# E293: EMY2017 PACCAR MX-13 EGR Flex Pipe Emissions Recall

Certain EGR flex pipes can crack and leak, causing exhaust after-treatment faults.

10,281 (8,610 US and 1,671 CAN) Model Year 2017-2019 T680, T800, T880, and W900 chassis built from 10/25/2016 through 01/24/2018 equipped with Engine Model Year 2017 PACCAR MX-13 engines.

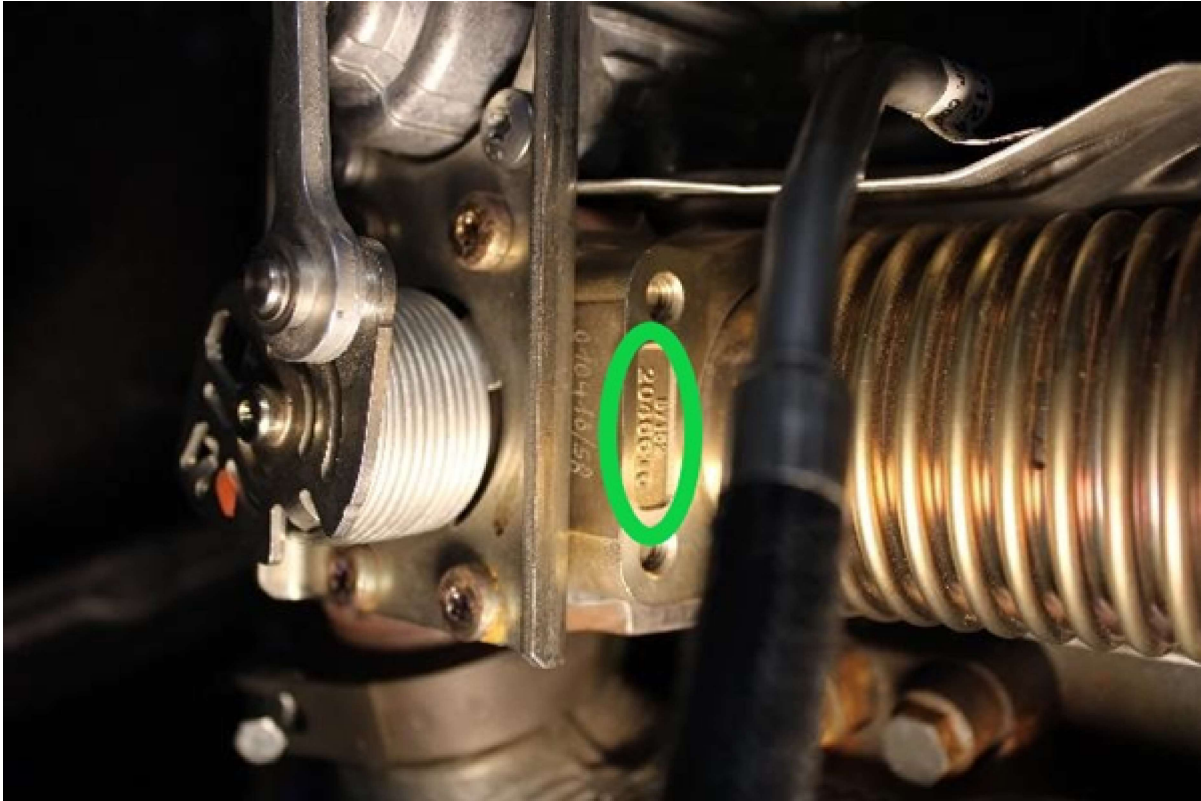
- If part number stamped on EGR flex pipe is **PN 2046616**, replace flex pipe using the attached procedures.

- If part number stamped on EGR flex pipe is **PN 2191702** or **PN 2318904**, *do not replace the flex pipe*. File a claim for inspection only and release the chassis.

<b>Quantity</b>	<b>Part Number</b>	<b>Description</b>
1	2318904PE	EGR Flex Pipe
1	2120190PE	Gasket, EGR (Flex pipe to EGR Valve)
1	1917870PE	Gasket, Exhaust (Flex pipe to EGR Cooler)
1	2035973PE	Gasket, Exhaust EGR (EGR Valve to Exhaust Manifold)
1	1979191PE	V clamp, 75.2mm (EGR valve to exhaust manifold)
1	1979190PE	V clamp, 82mm (Flex pipe to EGR Cooler)
2	2116602PE	O-ring, 7.4 x 2 (Coolant pipes to EGR Valve)
